Packet Guide
City of Charlottesville
Board of Architectural Review
Regular Meeting
April 15, 2025 5:30 p.m.
Hybrid Meeting (In-person at Council Chamber and virtual via Zoom)

Recommendation for Special Exception Permits

Certificate of Appropriateness Application

TREE PROTECTION REQUIREMENTS

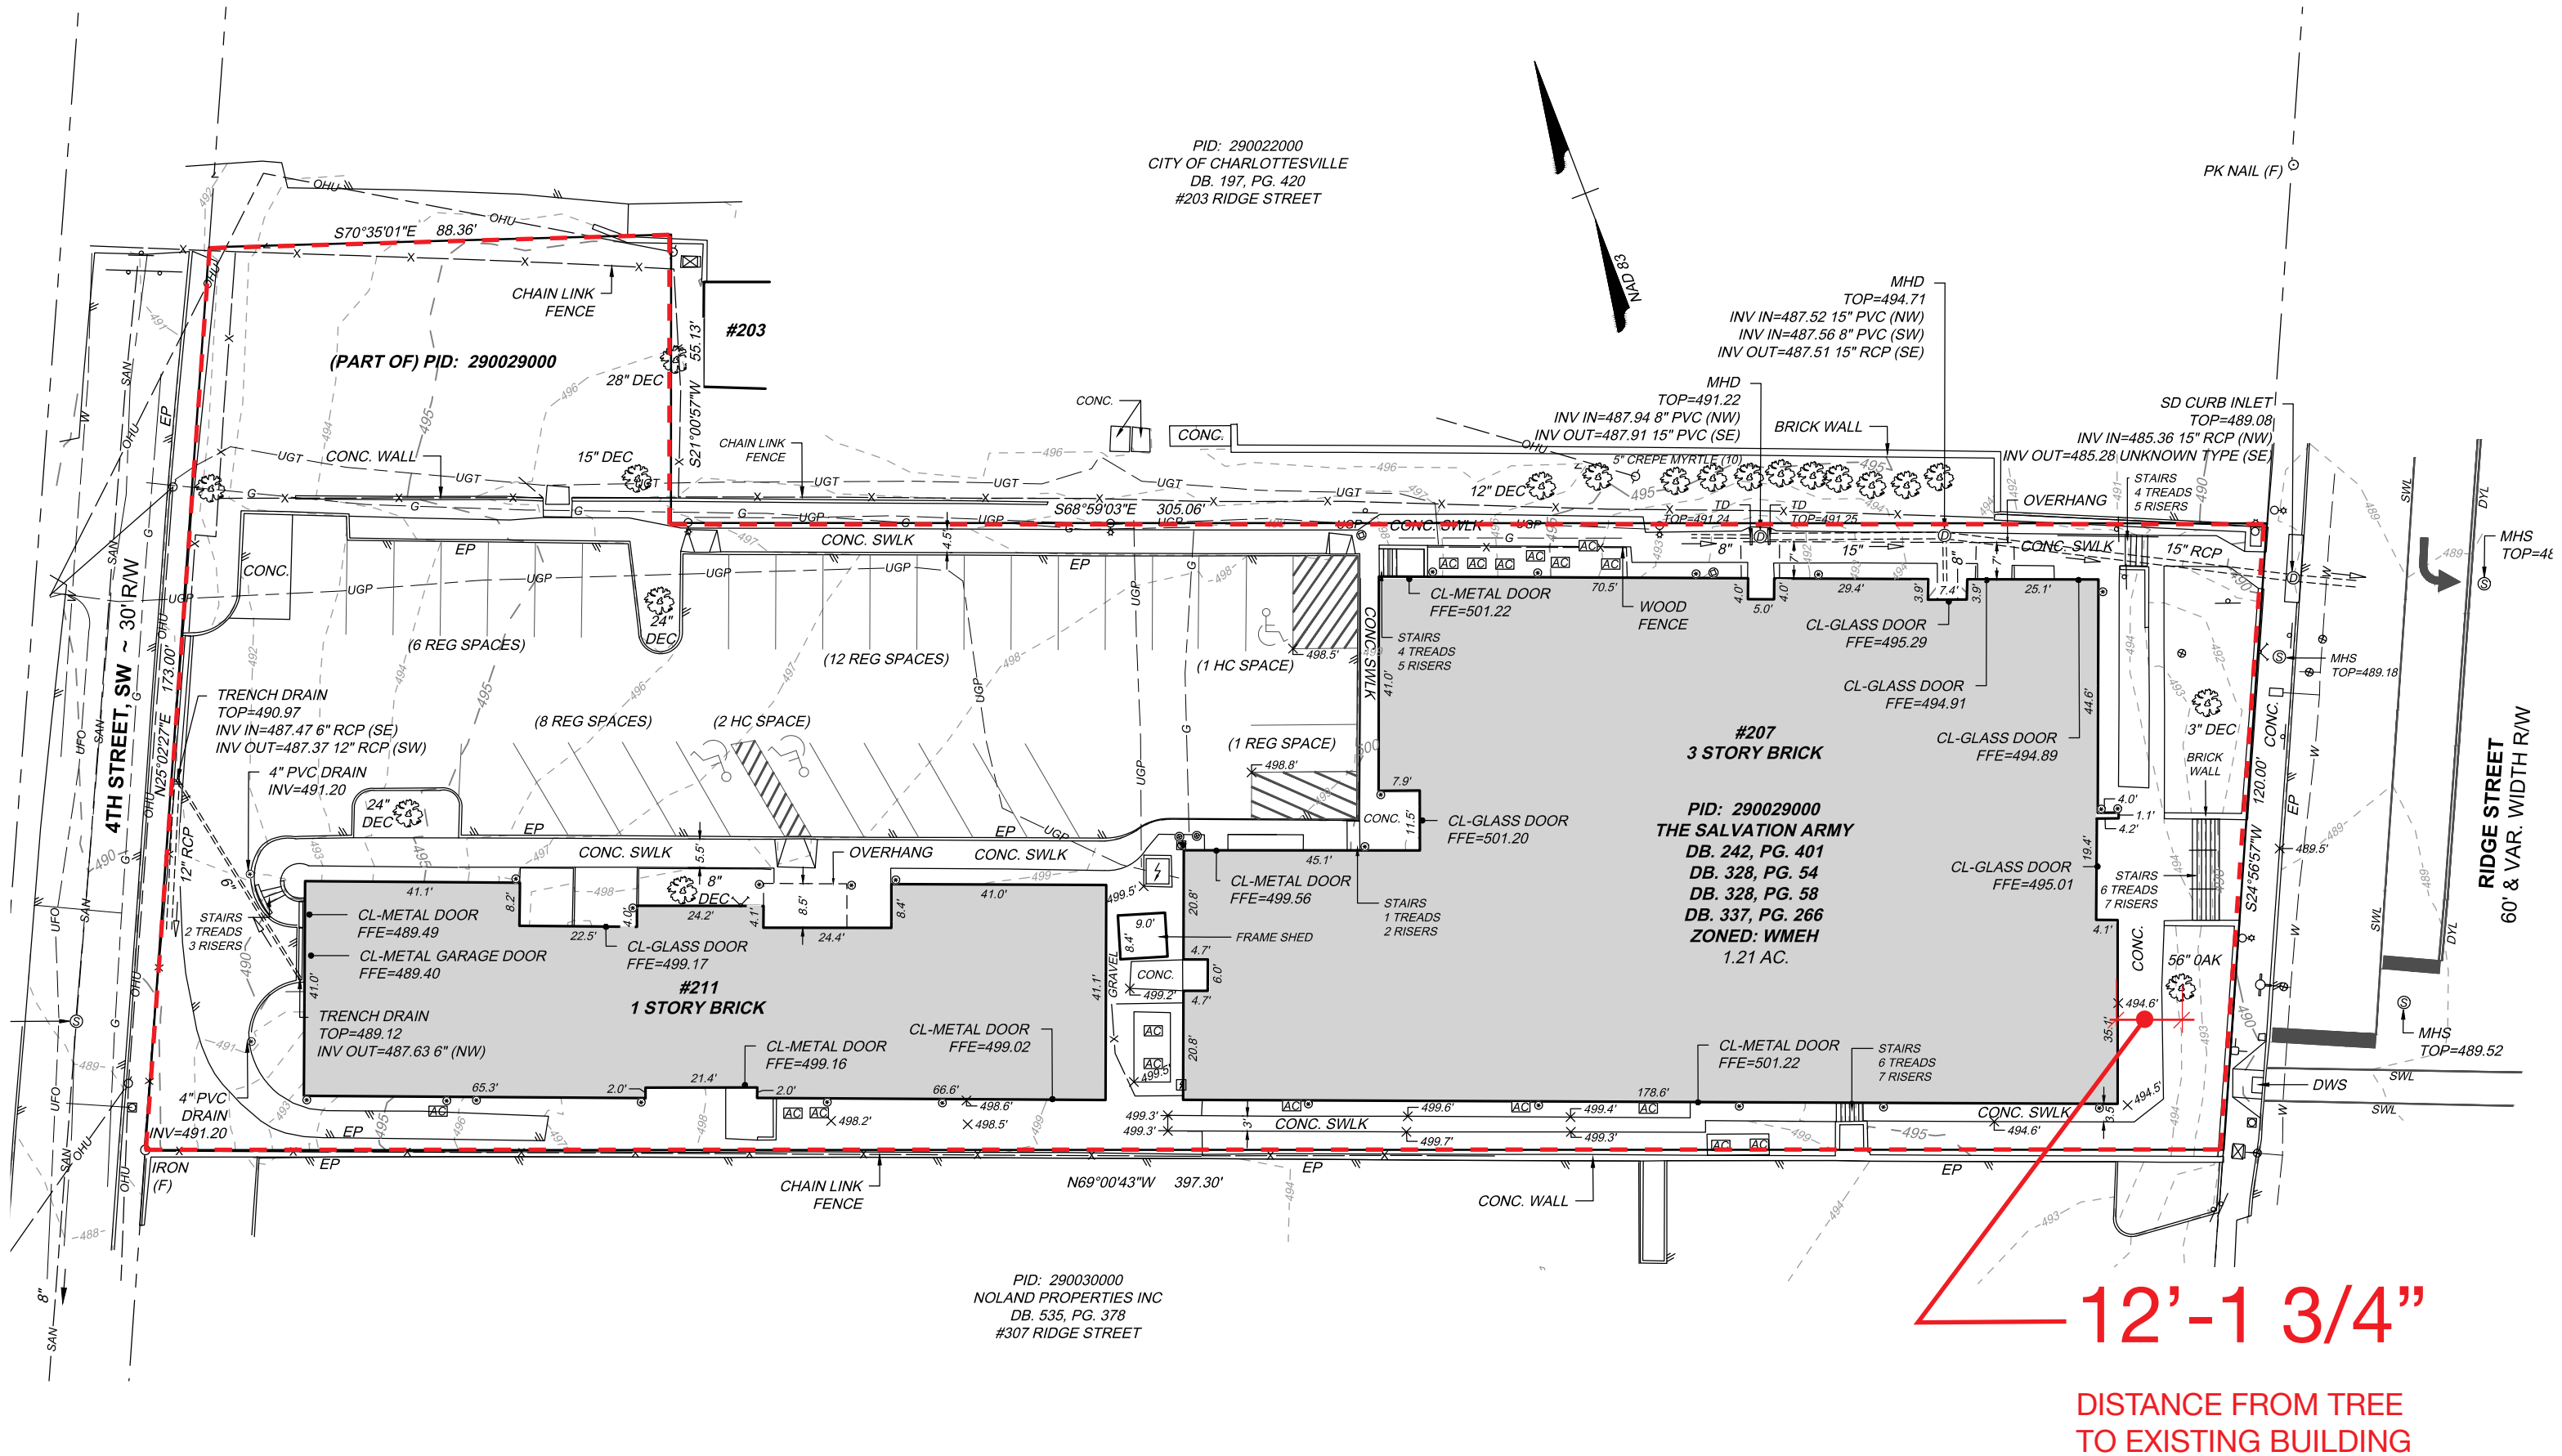
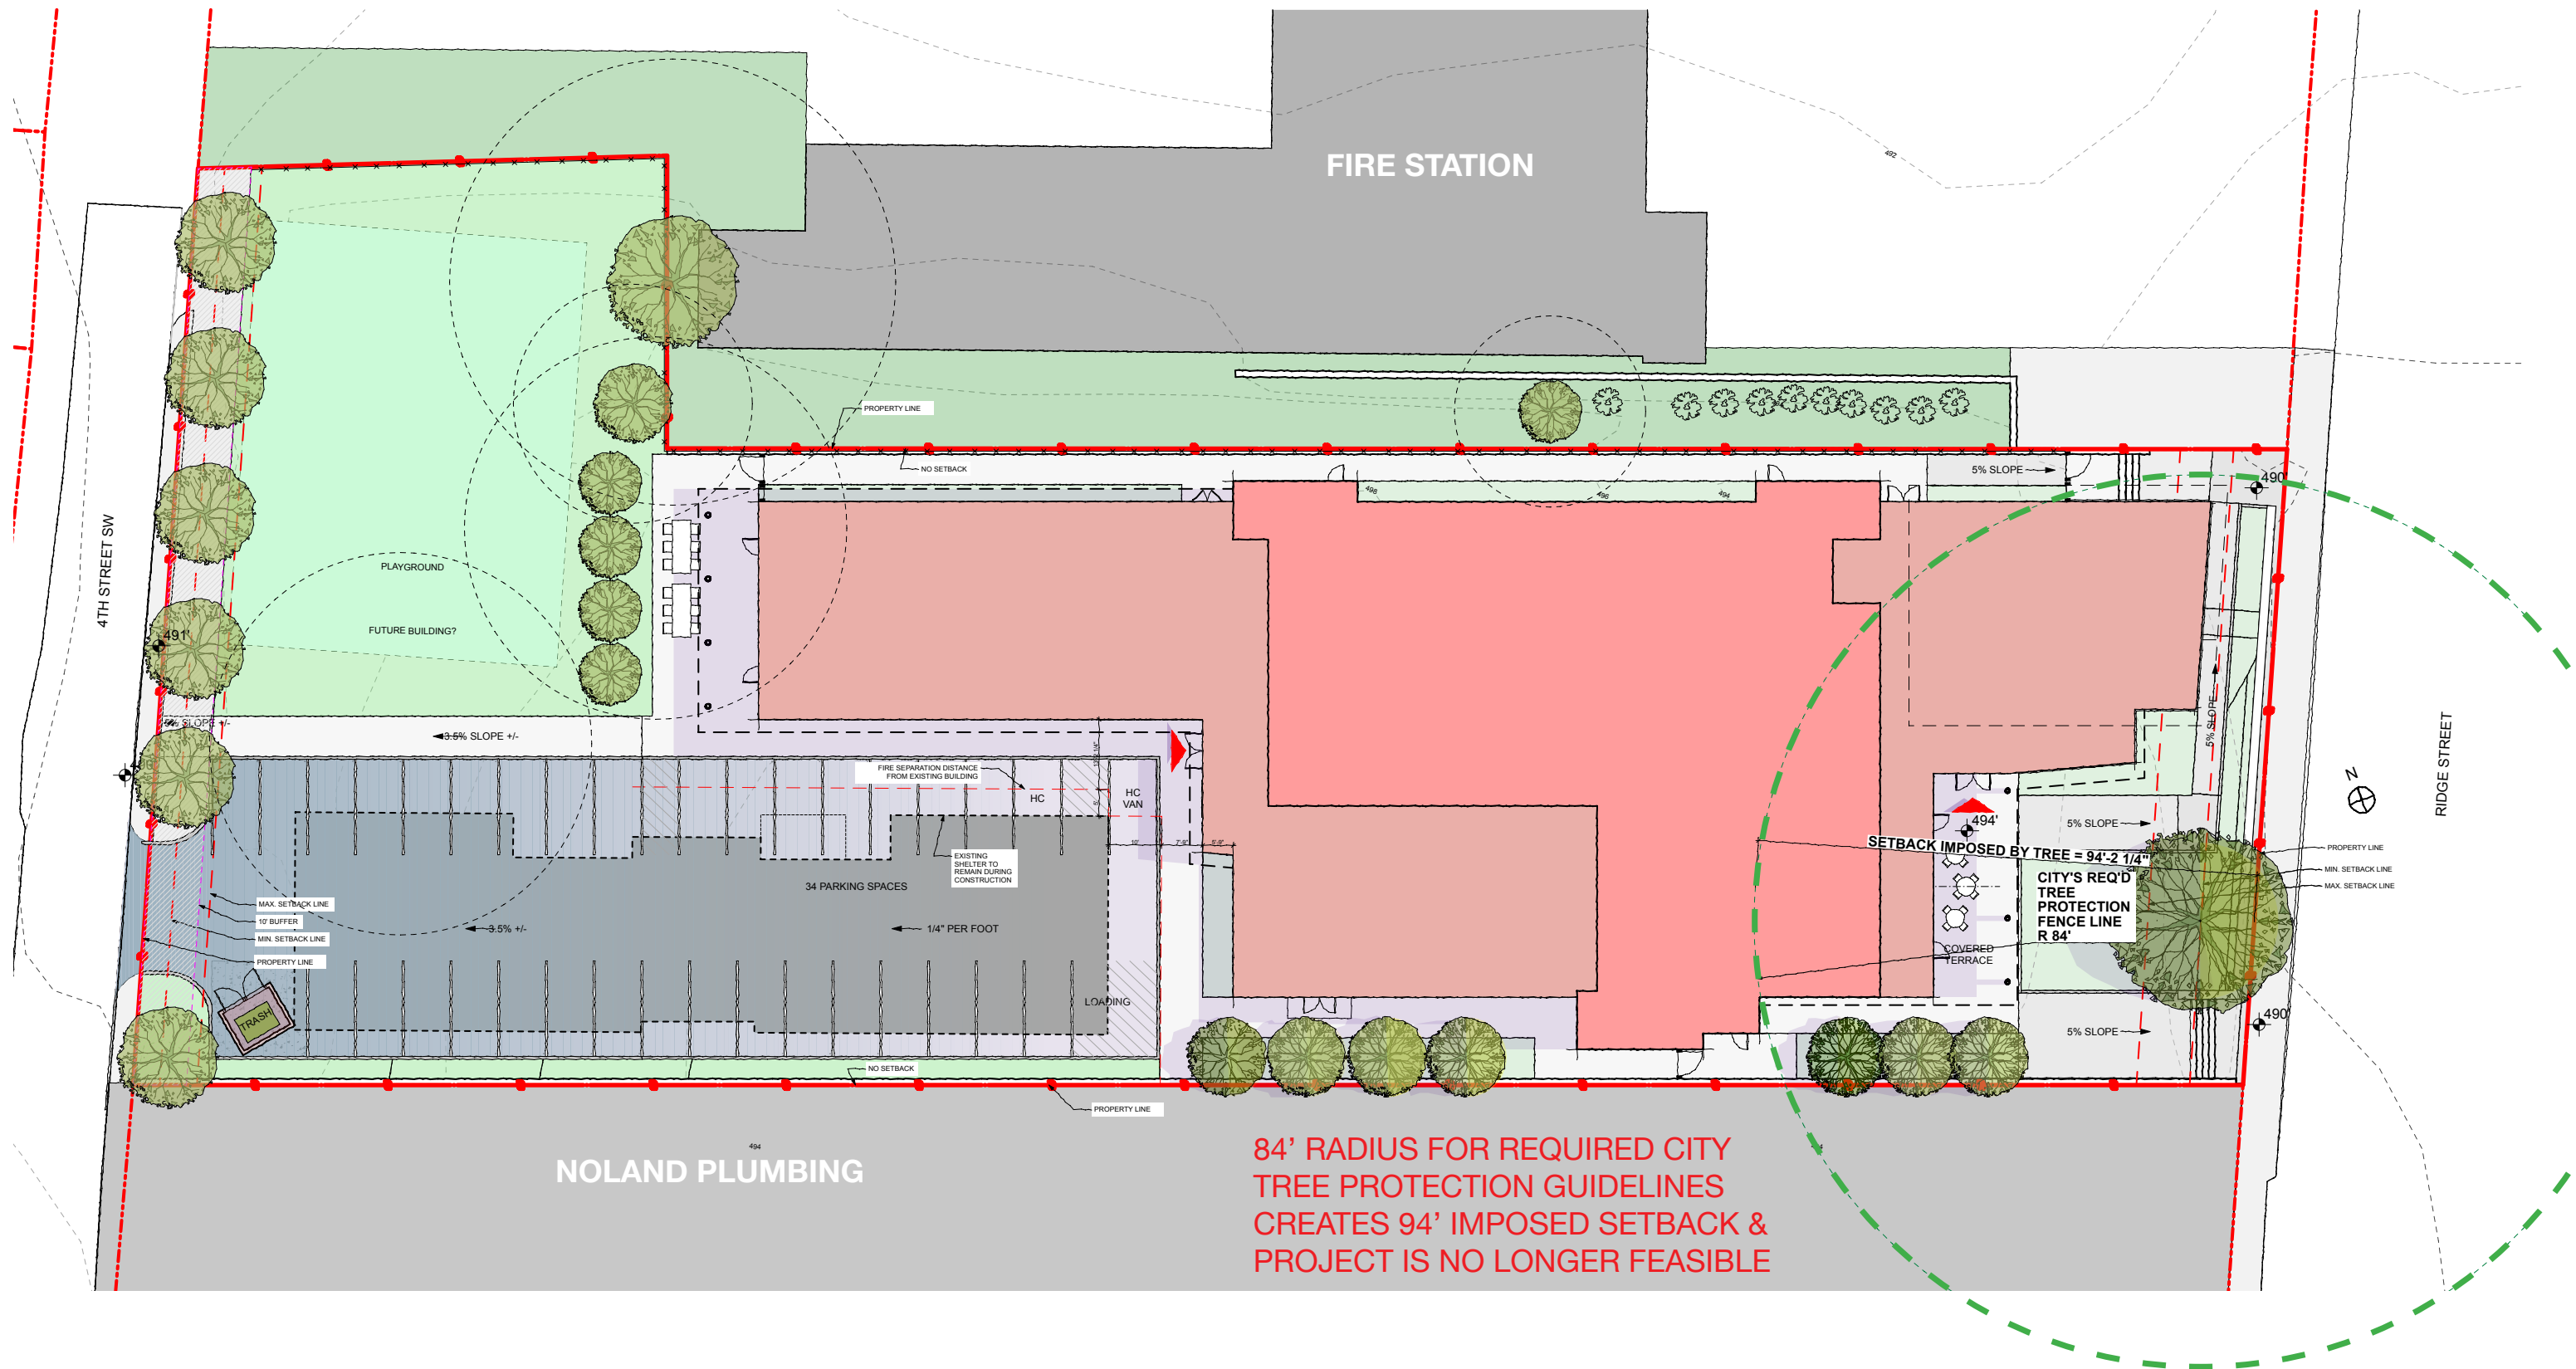
- The BAR does not find that the removal of the black oak at the front of the property is compatible with the guidelines and asks that the applicant develop a tree protection strategy based on the arborist recommendations submitted January 16, 2023. The applicant should apply all reasonable approaches to protect the tree during demolition and subsequent construction.
- The BAR recommends that the city engineer work with the applicant to review the tree protection plan that they have developed and adapt the city requirements to the particular context of this situation.

Sal's Pizza - D-03

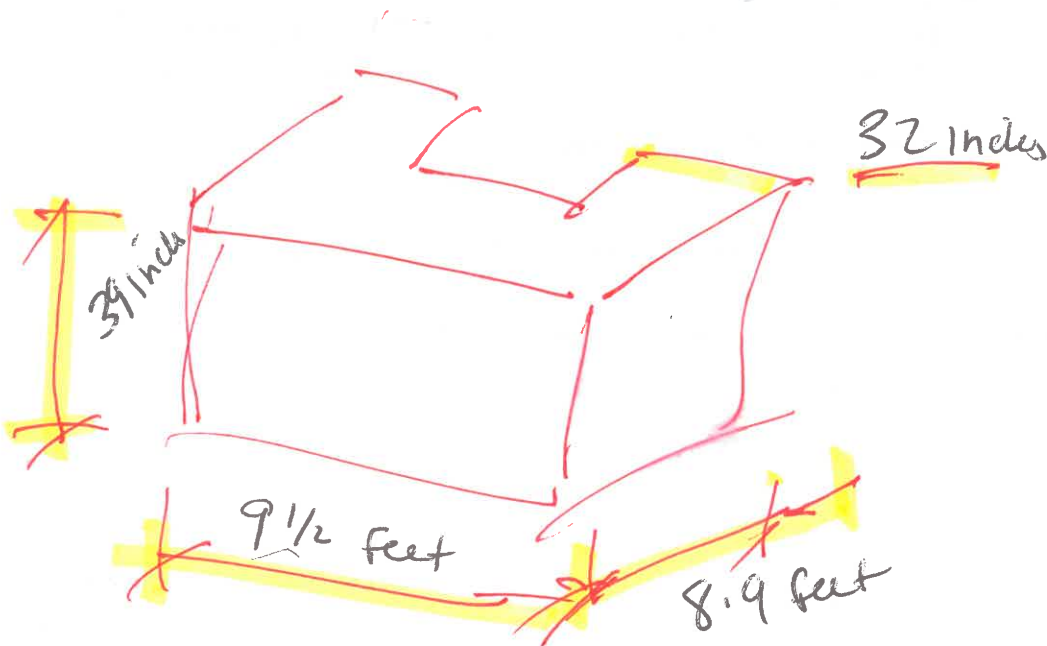
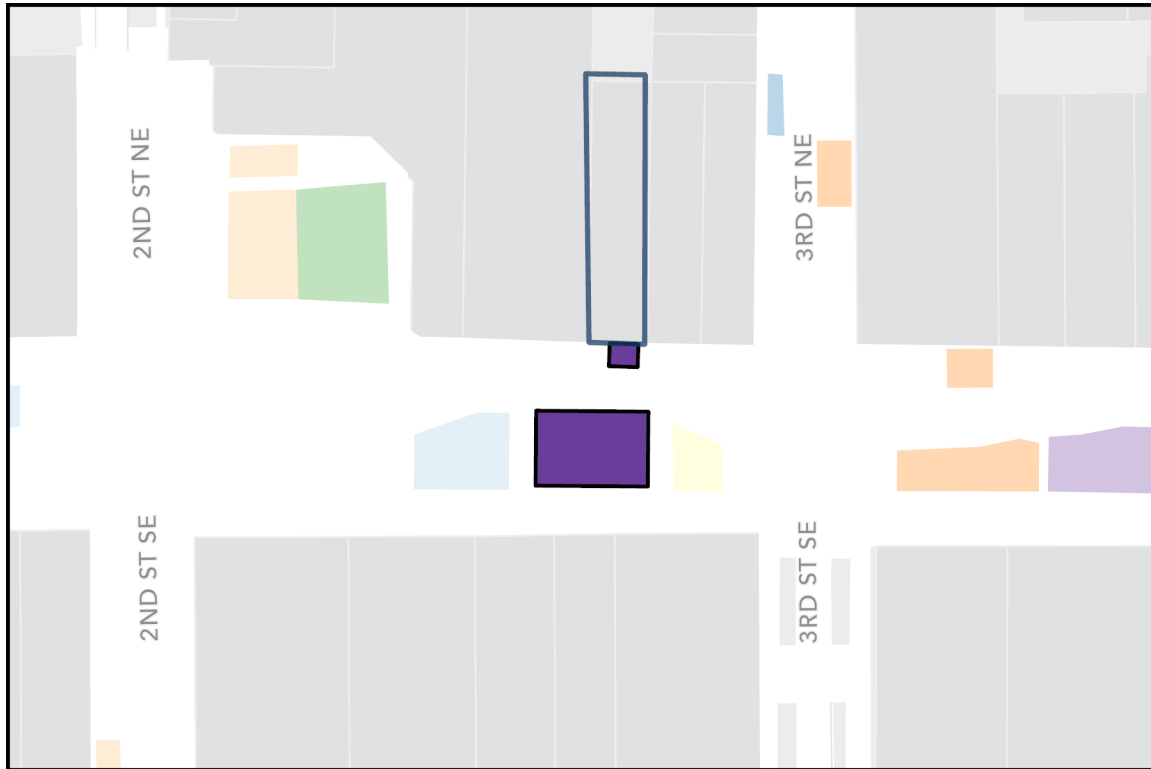
Staff comment: The serving counter is constructed as a single element and does not appear to be *portable and easily moved manually*.

Staff comment: Particle board is not a durable or high-quality material.

Staff comment: With the particleboard front and side panels, the serving counter reads as a solid element.

Staff comment: The serving counter is built directly on the tree grate, less than one foot from the tree trunk on all sides. To stabilize the cabinet, wooden braces span the gap and abut the tree trunk on two sides.

Staff comment: The serving counter is not well constructed. (That is, it was built in-place and is not a manufactured product.) The size, scale and configuration suggest an element that, while not anchored, cannot be easily moved or removed.

Staff comment: The serving counter is within one foot of the tree trunk, and the wooden braces abut the trunk. Potted plants sitting within the counter enclosure are directly in contact with the tree. Photographs taken by staff in June 2026 show plants wrapped around the tree trunk.
